**Flat 2, 55 Greencroft Gardens
London NW6 3LL**

**Basement Impact Assessment
Audit**

For
London Borough of Camden

Project Number: 12066-55
Rev: F1

Underpinning sequence

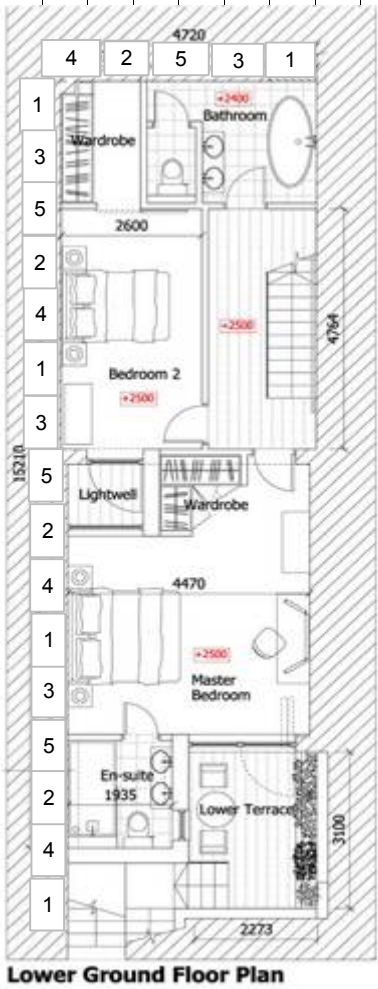
The CSM provides a detailed proposal for underpinning the party walls with no. 57 and Flat 3 of no.55. Whilst it is accepted that this can be achieved in principle, there are detailed aspects of the proposal that appear unacceptable e.g. the head of each pin should be propped horizontally to the existing Flat 1 underpinned wall before any excavation takes place, in order to minimise possible movement, until the sloping prop proposed can be bolted to the basement slab strip. Also greater clarity is required over the underpinning sequence below Flat 3's party wall. These concerns should be responded to either by the requirement for Basement Construction Plan or during the Party Wall Act approval process.

- 5.6. It is proposed to form the basement using underpinning techniques to two sides of the basement. Concerns remain over the detailed sequence of underpinning and temporary propping support of the head of each pin which should be clarified during the Party Wall process.

2.3 The Underpinning will be carried out in the sequence shown working on the pins in the order given ensuring that pins and underpinning have cured prior to adjacent pins being worked on. The underpinning sequence will be as follows to maintain stability and will include the formation of the LG floor slab to act as a prop between party walls.

Rev A u/pin
sequence added
